INCH-POUND
MIL-PRF-27639D
AMENDMENT 1
26 June 1998

PERFORMANCE SPECIFICATION

VALVE, PNEUMATIC INFLATOR (LIFE PRESERVER, FLU-1/P)

This amendment forms a part of MIL-PRF-27639D, dated 20 June 1997 and is approved for use by all Departments and Agencies of the Department of Defense.

FIGURE 1. Inflating Assembly

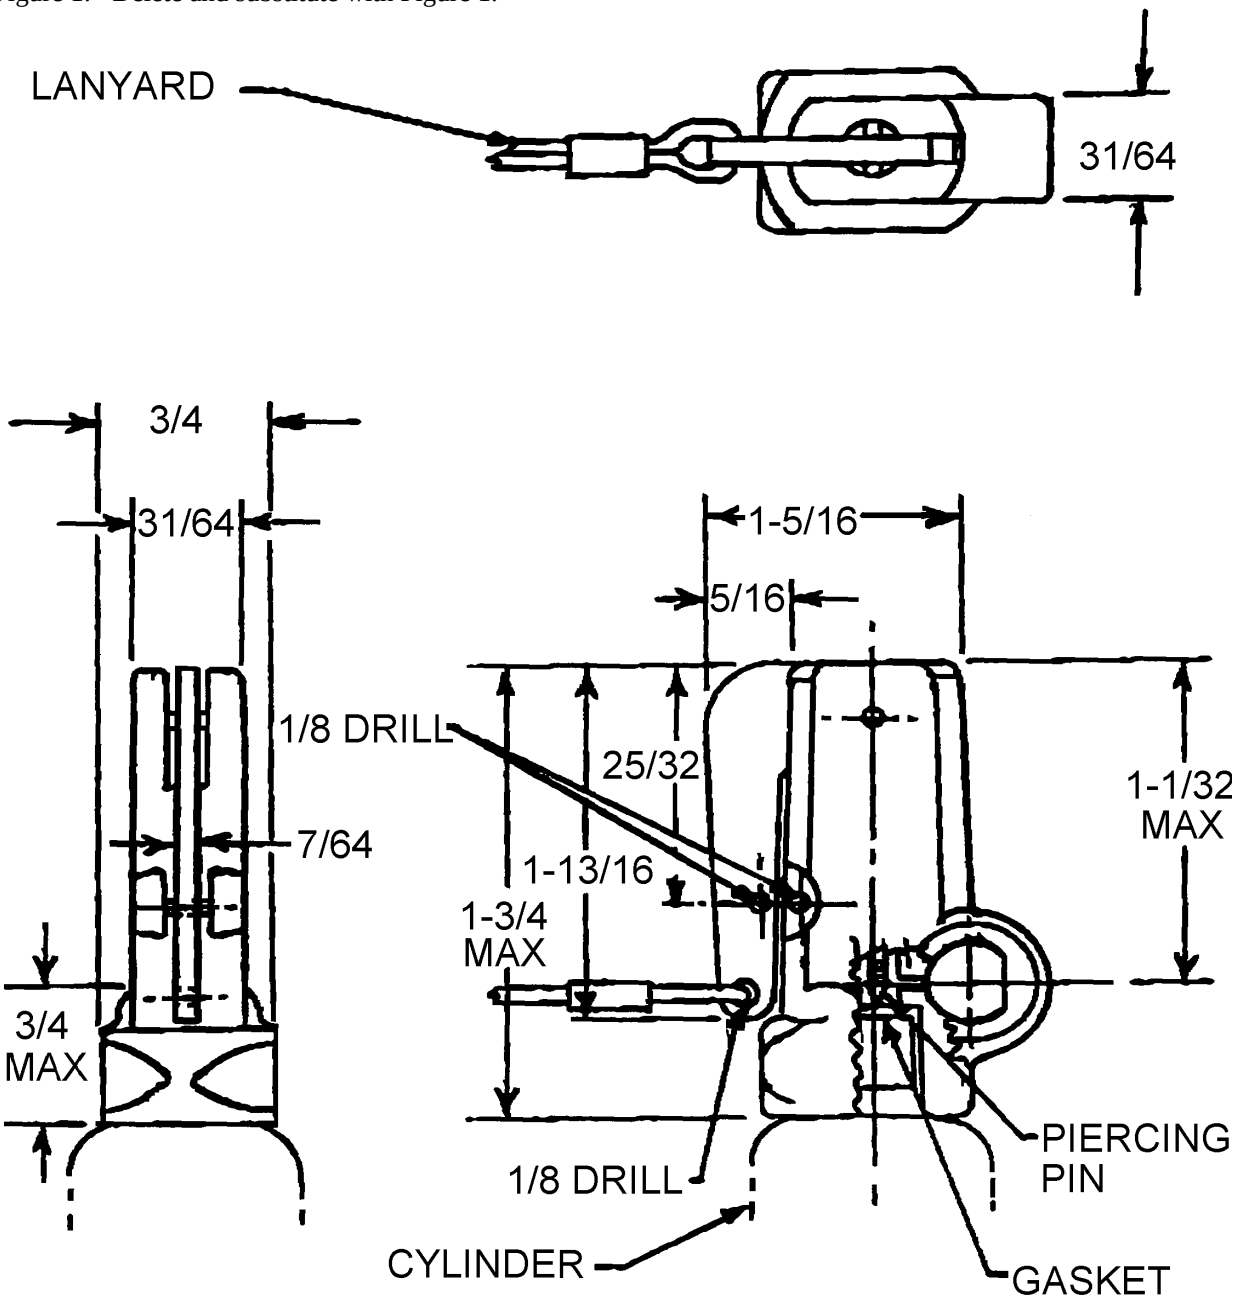
Figure 1: Delete and substitute with Figure 1.

NOTE: ALL CORNERS SHALL BE ROUNDED AND ALL BURRS SHALL BE REMOVED TEN-THOUSANDS RADIUS REQUIRED ON LEVER EDGES.
